CITY OF NORMAN, OK HISTORIC DISTRICT COMMISSION MEETING

Municipal Building, Council Chambers, 201 West Gray, Norman, OK 73069
Monday, August 05, 2024 at 5:30 PM

AGENDA

4. (HD 24-13) FEEDBACK DISCUSSION REGARDING A FUTURE REQUEST TO DEMOLISH THE EXISTING GARAGE AND CONSTRUCT A NEW SINGLE-FAMILY HOUSE WITH AN ACCESSORY DWELLING UNIT FOR THE PROPERTY LOCATED AT 505 CHAUTAUQUA AVENUE.

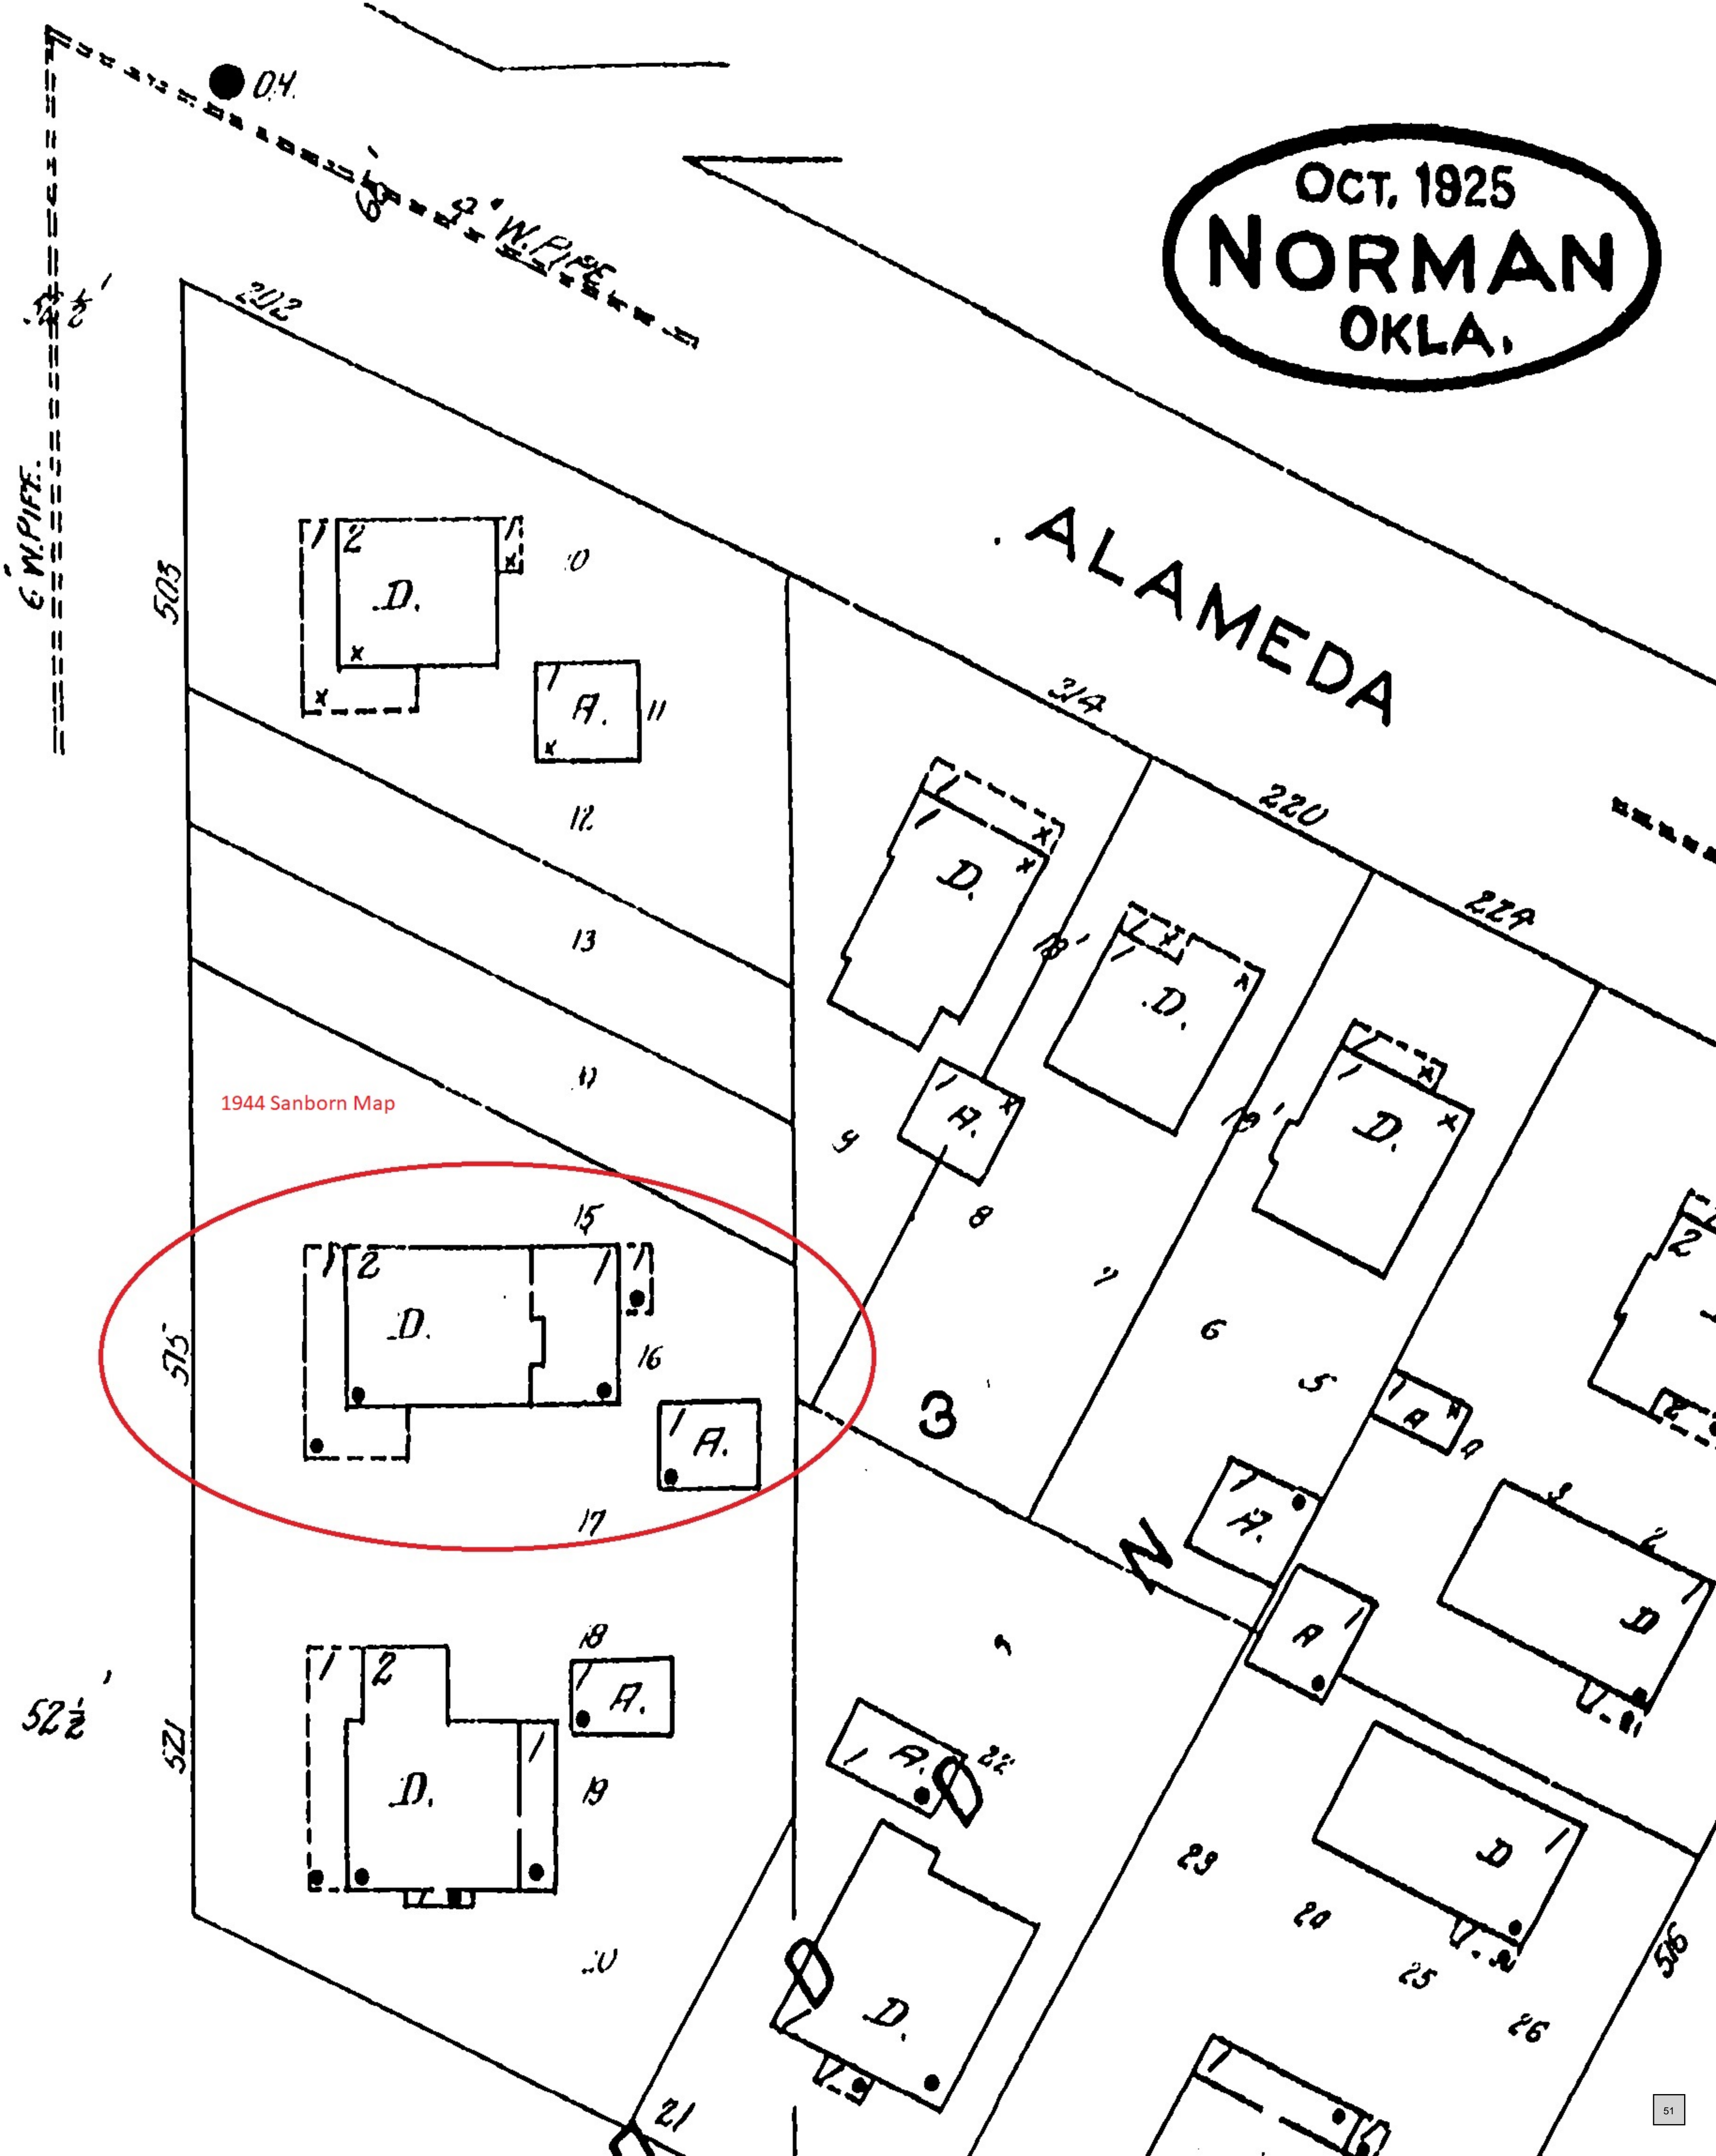
The proposed concrete does not meet the criteria for the Administrative Bypass approval by staff since it is visible from the front right-of-way.

Staff would note that while the current owners do not wish to use this additional area as parking, future owners may utilize it for parking. The proposed concrete area meets the Zoning Ordinance Core Area Parking regulations. The total impervious surface with the addition of the proposed concrete area will be 48%, which is below the 65% maximum allowed per the Zoning Ordinance. This property does not have alley access, which makes installing a basketball hoop and surface in a rear location more difficult.

1 WEST ELEVATION
SCALE: 1/4"=1'-0"

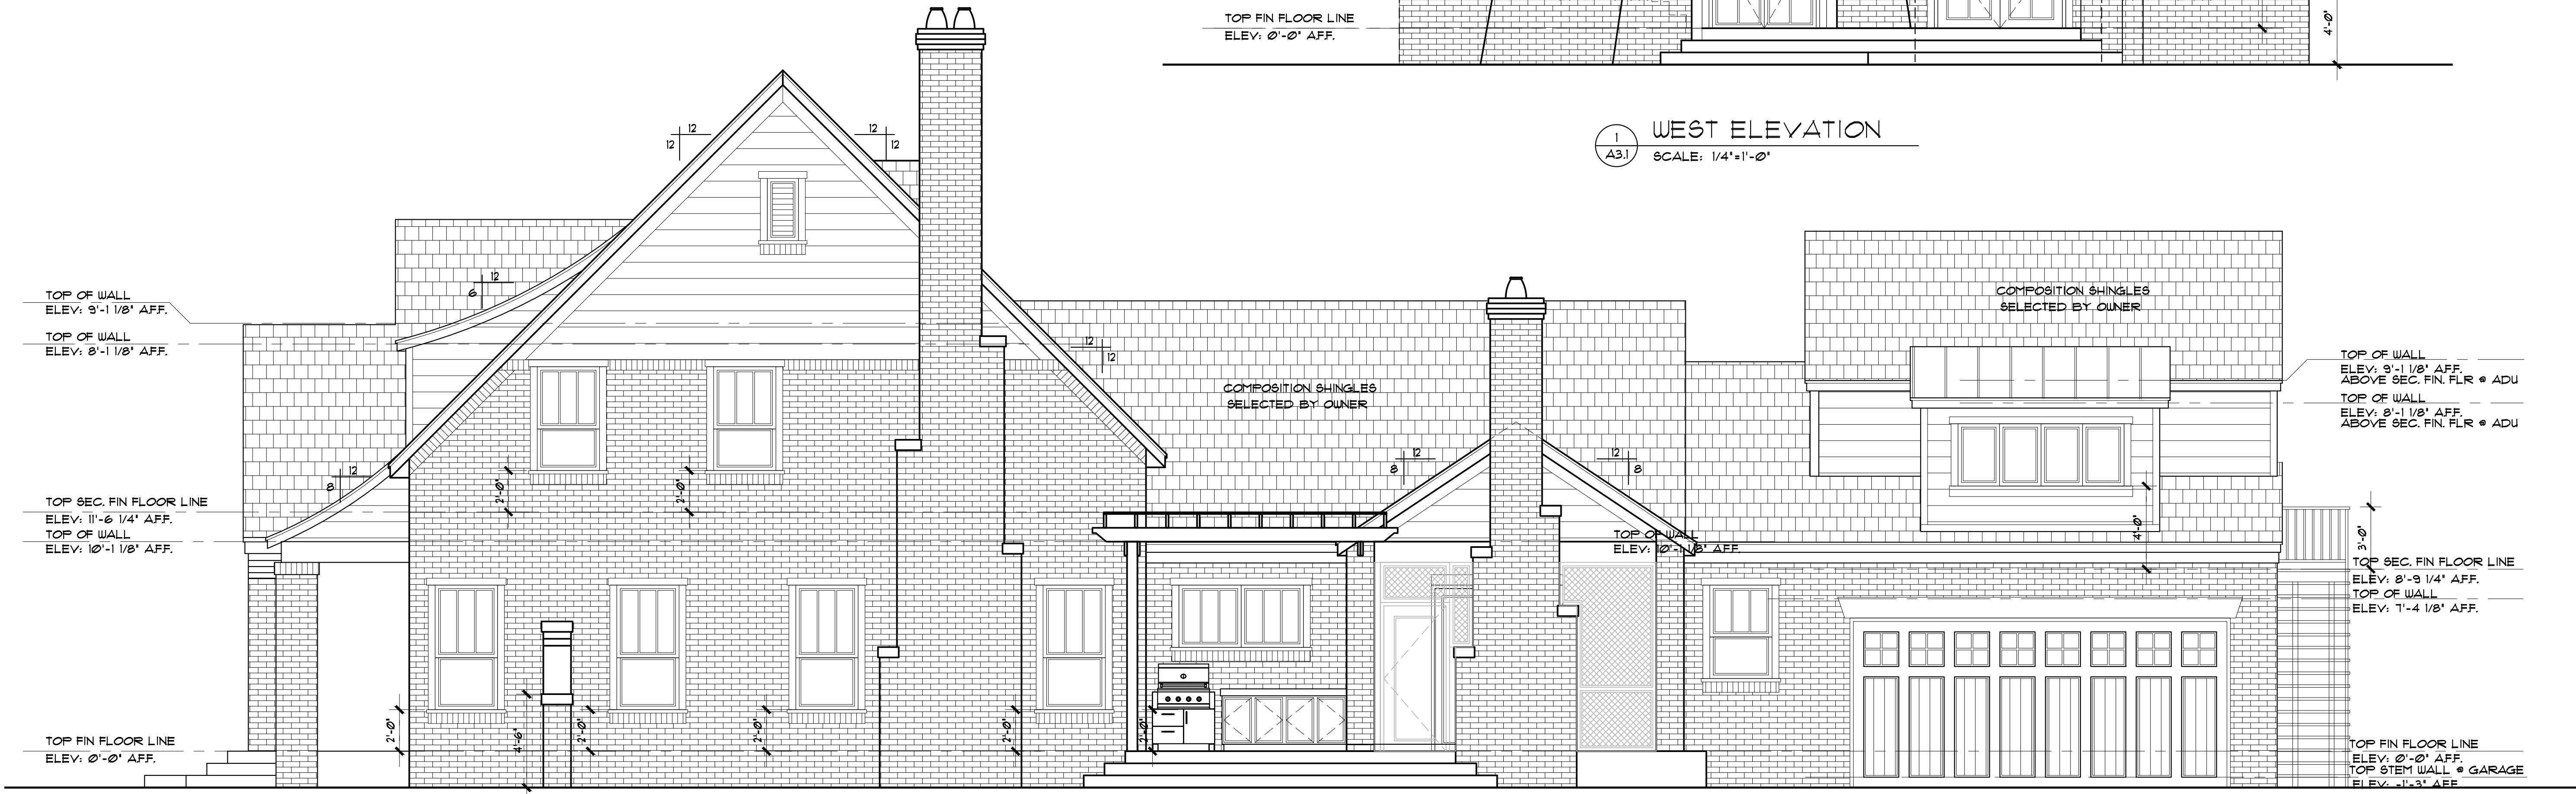
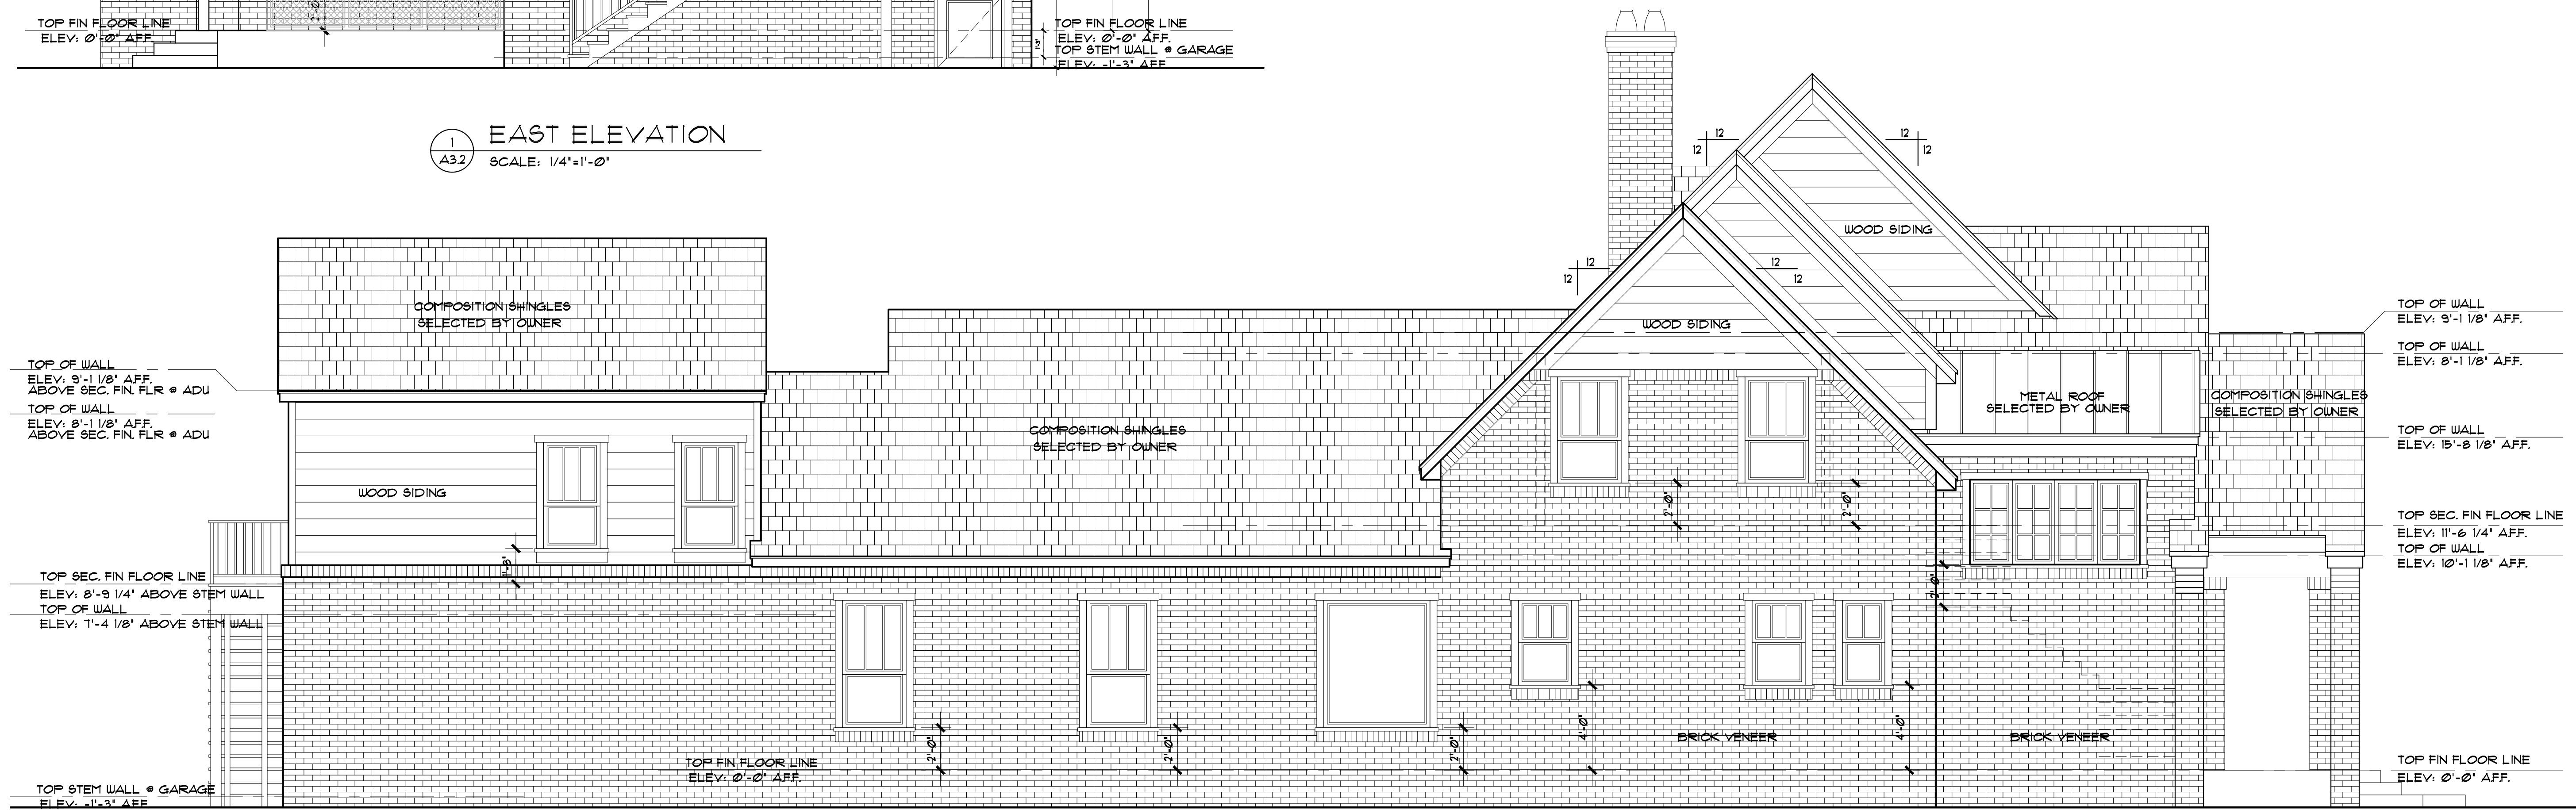
The applicant proposes a two-story house with a height of 32' 9". According to the submitted streetscape elevation, the proposed height is taller than the existing houses at 507 Chautauqua and 447 Chautauqua. The specific heights for the adjacent structures were not provided. The submitted streetscape drawing also indicates the proposed house is wider than adjacent houses at 447 and 507 Chautauqua. Again, dimensions were not provided.

The Commission needs to provide feedback on whether the proposed size, scale, and height, for the new house meet the *Guidelines* and is compatible with the Chautauqua District.

The Commission would need to provide feedback on whether metal “French door” style entrance doors and set of windows on the front façade are compatible with the Chautauqua District. Additionally, the Commission should provide feedback on whether the size, proportion, and pane configuration of the remainder of the proposed windows meet the *Guidelines*.

The Commission would need to provide feedback on whether a metal accent roof on the front façade meets the *Guidelines* and is compatible with the Chautauqua Historic District.
